## Safety Recall Launch Notification

Campaign #	NHTSA ID	Description	<b>Replace Front Short-Range Radar Sensor</b>
2025110002	25V711	25P3091002

# Recall Campaign Bulletin

CAMPAIGN NO.	<b>2025110002</b>
CAMPAIGN DESC.	<b>25P3091002</b>
NHTSA ID	<b>25V711</b>
SUBJECT	<b>Replace Front Radar Sensor</b>
MODEL(S)	<b>G-Class (465 platform)</b>
MODEL YEAR(S)	<b>2025</b>
CAMPAIGN POPULATION	<b>12</b>

Figure 1

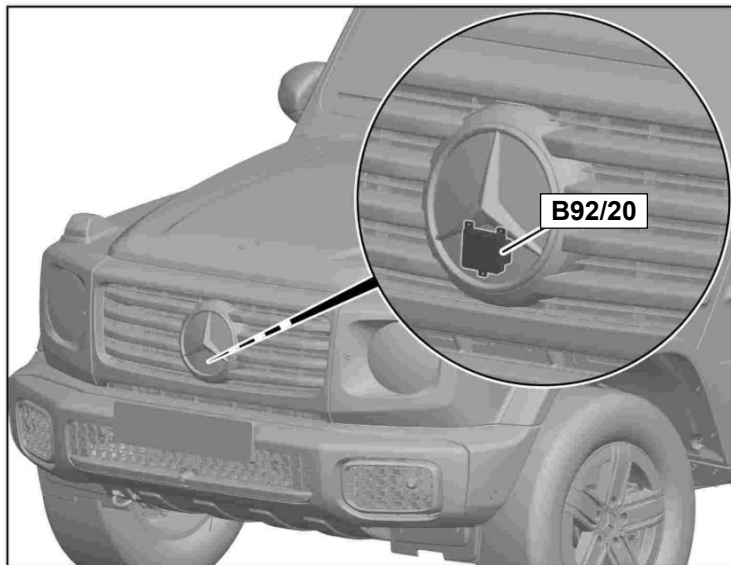
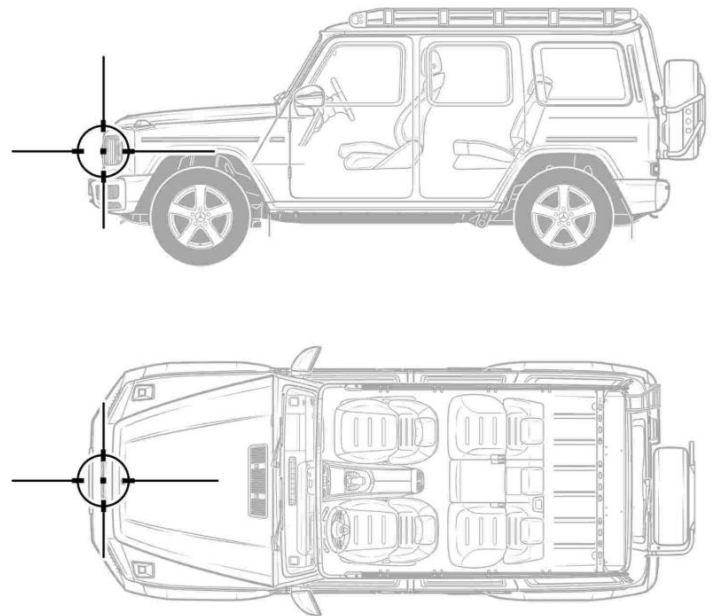
1. Replace front **Midrange radar (B92/20)**.
